BENTLEY MEADOWS

RE: SUB 2001-17 -- One-Step Final Plat of Bentley Meadows Addition

STAFF REPORT

CASE NUMBER: SUB 2001-17 -- BENTLEY MEADOWS ADDITION

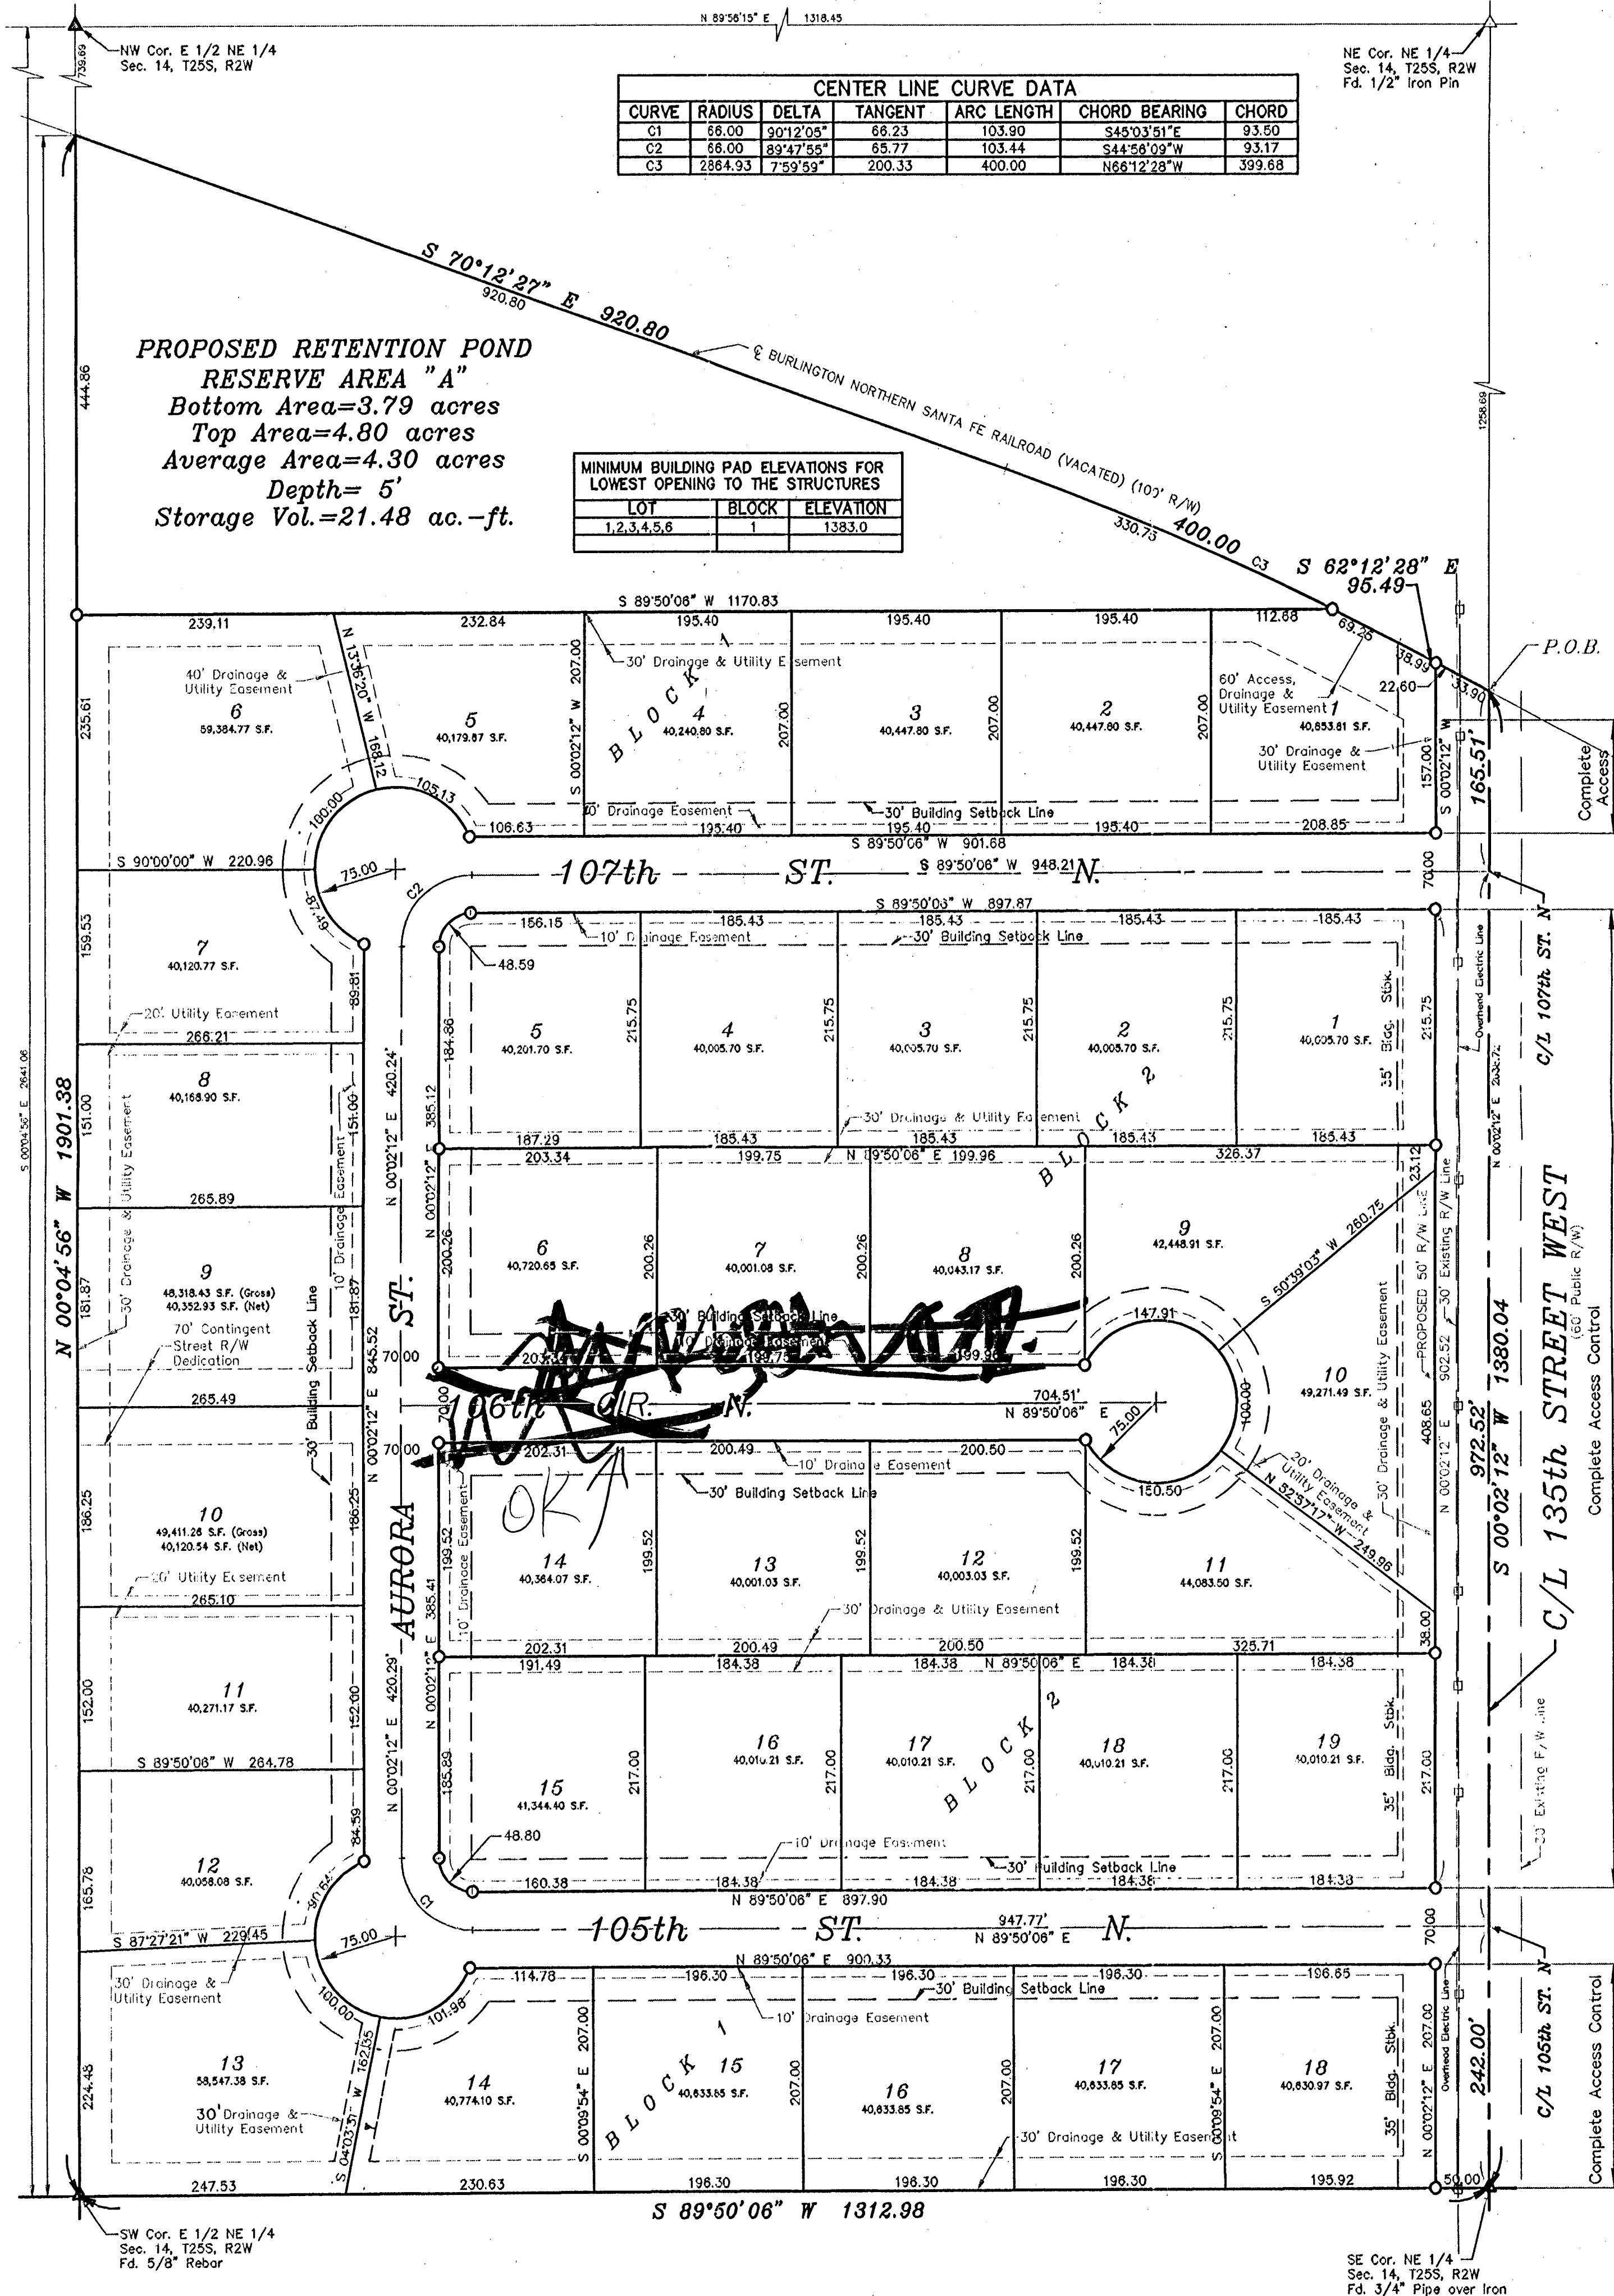
- C. A revised drainage plan is needed to reflect the new lot layout. The drainage plan needs to identify outlet for the detention pond and method of achieving positive drainage away from the site.

- D. The plat shall be corrected to reference complete access control along the plat's frontage to 135th St. West. The final plat shall reference the access controls in the plat's text.

- H. County Fire Department needs to comment on the plat's street names. Hunter needs changed to Aurora Ct. Emily needs changed to 105th St. N. Autumn needs changed to 107th St. N.

- J. Because of the landlocked nature of Reserve A, a means of access shall be provided to such a Reserve.
- K. In accordance with the zone change approval, the applicant shall provide a guarantee for a four-inch layer of "AB-3" rock sub-surface, and a two-inch layer of sand and gravel surface material, to be placed on 135th Street adjacent to this property extending to 109th St. This improvement shall be done to the existing standards of the county, and shall be approved by the County Public Works Director.

- N. On the final plat, the MAPC signature block needs to reference "Bernard A. Hentzen, Chair".
- O. County Surveying has advised that property corners to be installed need shown.

- P. The centerline of Emily Street and Autumn Street needs located along the section line.
- Q. The dimension on the east line of Lots 9 and 11, Block 2, needs added.

- R. Block 1 has duplicate Lot numbers, and needs renumbered.
- S. Block 2 needs labeled.
- T. The curve data on the north line of the subdivision needs shown on the face of the plat.
